FIRMWARE RELEASE NOTE

DS-K5603-Z Series Face Recognition Terminal Release Notes (2018-08-27)

Device Model:	Firmware Version	ARM: ACS_5603_15_AIO_CN_GM_V1.1.0_build180827 MCU: ACS_DS-K560X_GML_GM_V1.0.0_build180706
	SDK Version	HCNetSDKV5.3.6.15_build20180705_win32
DS-K5603-Z	4200 Version	V2.6.10.14_build20180824
	Ehome Version	EhomeSDK_V1.2.1.13_build20180803_win32

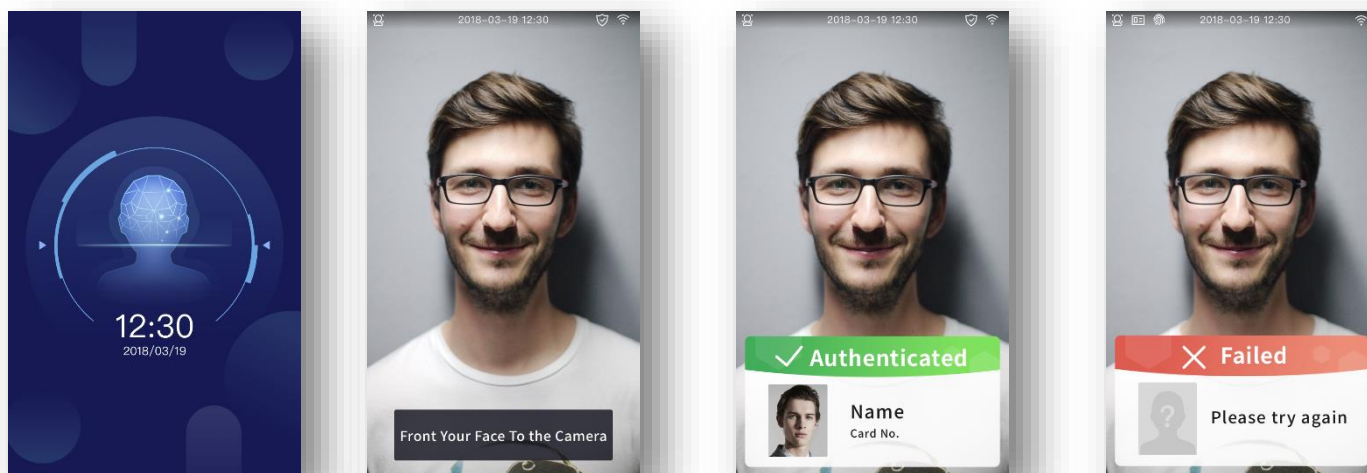
1. Improved face recognition and live face detection algorithm.

When upgrading from 1.0 to 1.1 firmware all face pictures information will be re-modeled. If the process fails for a particular picture, the information will be uploaded to the client software.

2. New user interface design:

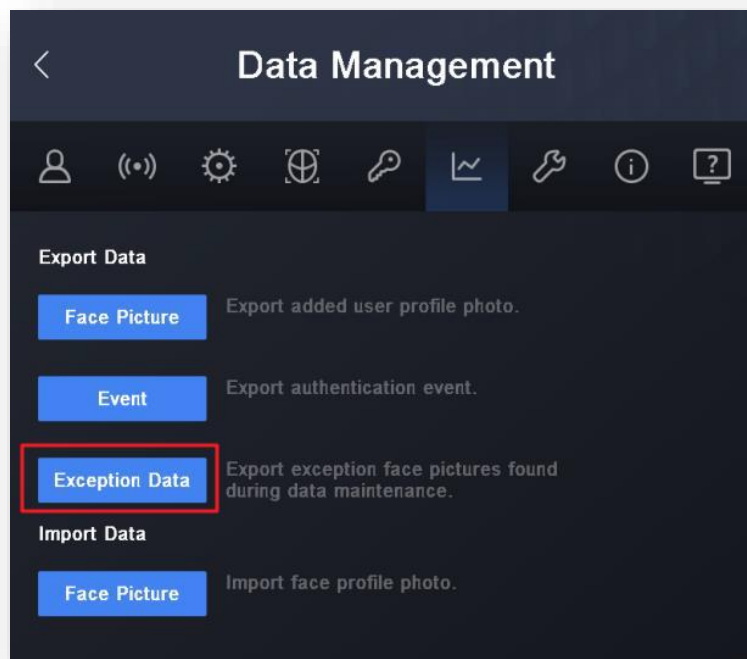
5. Default Settings will delete all user information while keep all events information.

5. Default Settings option will delete all user information while keep all events information.
6. When using Ehome communication, device will still support apply, get, delete or remote collect face picture by the client software.
7. Face picture and modeling information can applied simultaneously.
8. If an upgrade file is present on a USB drive plugged in, the terminal will auto upgrade upon power on.
9. On Standby mode, screen will show date and time status.
10. Added 'Exception Data' icon to export exception data to USB flash drive.
